審查意見摘要表

(第六章 ~ 第九章)

RESPONSES TO ROC-AEC's PSAR QUESTIONS

Figure 7.9-3 Configuration of RPS/MSIV and EMS Interface

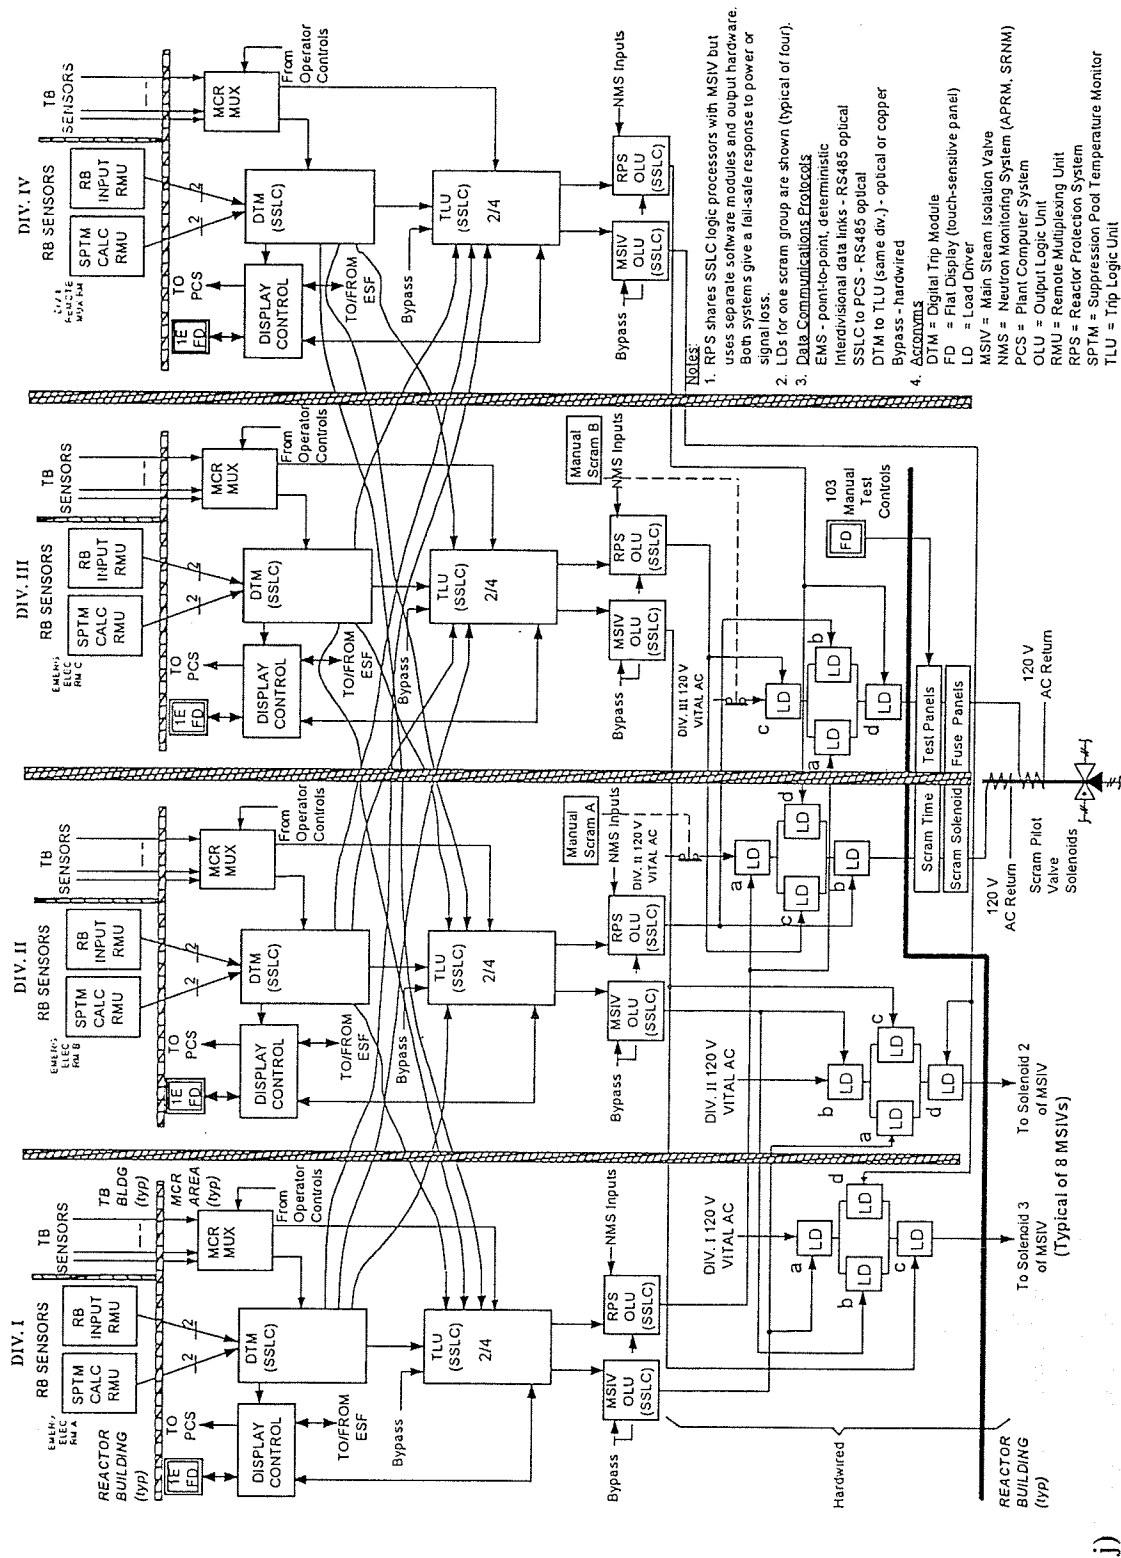
The response to Item 3 of 07-009 says: "EMS system configuration has been changed since the issuance of PSAR. GE has been in discussion with TPC about this change. However, no final approval has been received. When the final decision is made, a detailed description and Figure 7.9-3 will be provided regarding the EMS system configuration." Response with open action is not acceptable.

The EMS acquires both analog and digital signals from remote process sensors and discrete monitors located within a plant and multiplexes the signals by redundant fiber optic lines to the MCR for transmission to the Reactor Protection System (RPS) and Engineered Safety Features (ESF) portions of Safety System Logic & Control (SSLC), and other divisional controllers. Within each division of EMS there are two separate networks, one for RPS/MSIV (see Figure 7.9-3) and one for ESF (see Figure 7.9-3a), which are independent from one another.

- i) Figures 7.9-3 and 7.9-3a as shown below will be appended to the end of Section 7.9 with the other figures in this Section.
